# UNITED STATES PATENT AND TRADEMARK OFFICE

APPLICATION NO.	FILING DATE	FIRST NAMED INVENTOR	ATTORNEY DOCKET NO.	CONFIRMATION NO.
10/620,410	07/15/2003	Andrew Sahr	17239	9612
26637	7590	04/06/2004	EXAMINER	
INTELLECTUAL PROPERTY LAW DEPARTMENT CASE LLC 700 STATE STREET RACINE, WI 53404			KOVACS, ARPAD F	
		ART UNIT		PAPER NUMBER
		3671

<b>Office Action Summary</b>	<b>Application No.</b>	<b>Applicant(s)</b>
	10/620,410	SAHR ET AL.
	<b>Examiner</b>	<b>Art Unit</b>
	Árpád Fábián Kovács	3671

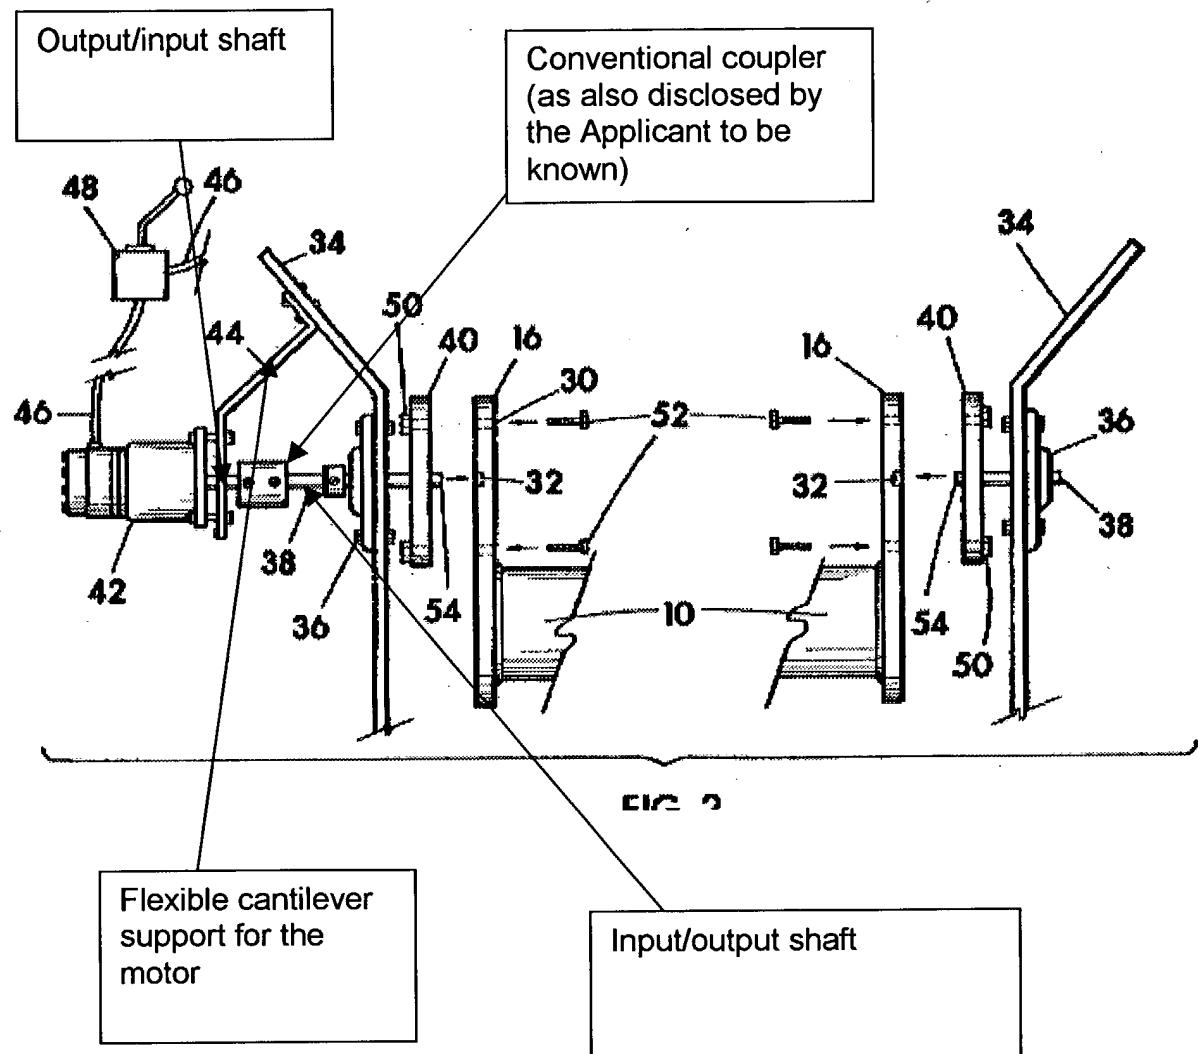
Garza discloses a harvester combine having a hydraulic motor (42) flexible support (44) output shaft and input shaft to another device to be rotated (col. 8, 1<sup>st</sup> paragraph), and shown in the marked up drawings below:

Garza discloses the claimed device except for being used for a cleaning fan assembly.

It would have been obvious to one having ordinary skill in the art at the time the invention was made to provide the motor support of Garza for any other device utilizing a motor, including a fan assembly, since it is well known to provide a support for a motor and Garza's motor support is just one of the many possibilities, which can also provide for an easy replacement of the motor when burns out or becomes defective.
